Proposed Eagleton Quarry EIS - State Significant Development Submission

Technical review supporting Boral Resources (NSW) Pty Ltd's submission on the
proposed development

Prepared for Boral Resources (NSW) Pty Ltd | 3 March 2017

Report J17034RP1 | Prepared for Boral Resources (NSW) Pty Ltd | 3 March 2017

Figure 2.1 Example water balance model results

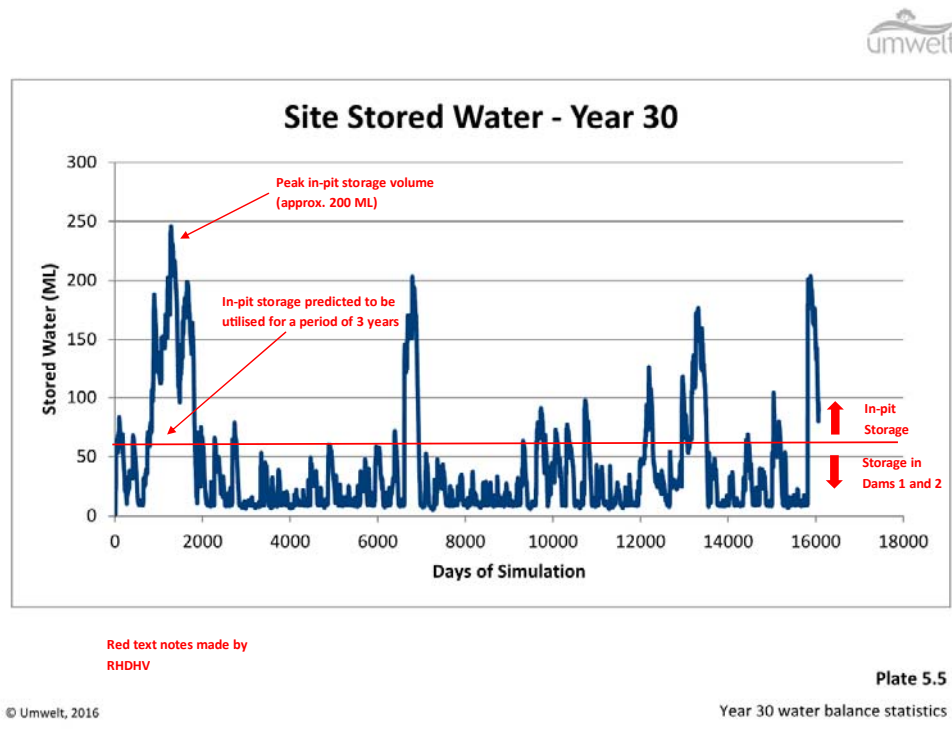
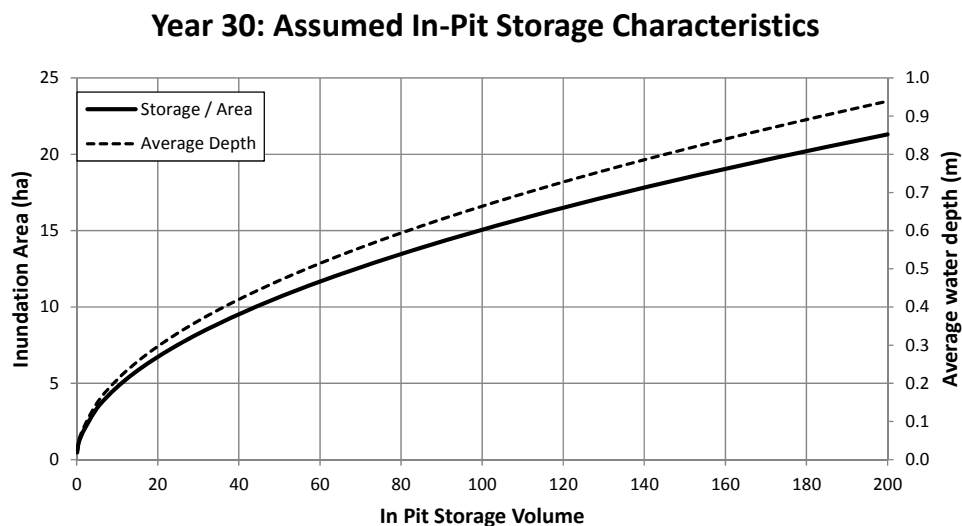
Water balance results presented in the WA indicate that the proposed in-pit storage will potentially store large volumes of water for extended periods of time. By way of example, Figure 2.1 below shows the Year 30 results, which indicate that up to 200 megalitres (ML) of water could be stored in in-pit storage. This is equivalent to nearly 80% of the quarry's total water storage (at Year 30). The results also indicate that in-pit storage could be required for periods of up to three years.

The WA has not adequately explained how the proposed in-pit storage concept will be achieved with the following significant concerns raised in relation to functionality:

- the quarry floor is expected to grade at 2.5% to the south making the shallow storage of water near impossible;
- the in-pit storage concept will require nearly the entire extraction area to be inundated with shallow water. The storage of water on the pit floor will therefore impede quarry operations and is therefore not considered to be a practical water management control; and
- if, on review the assumed in-pit storage concept cannot be achieved, a revised concept would likely significantly reduce the assumed evaporation area which in turn will materially reduce the potential for evaporation losses (see water balance assumptions below).
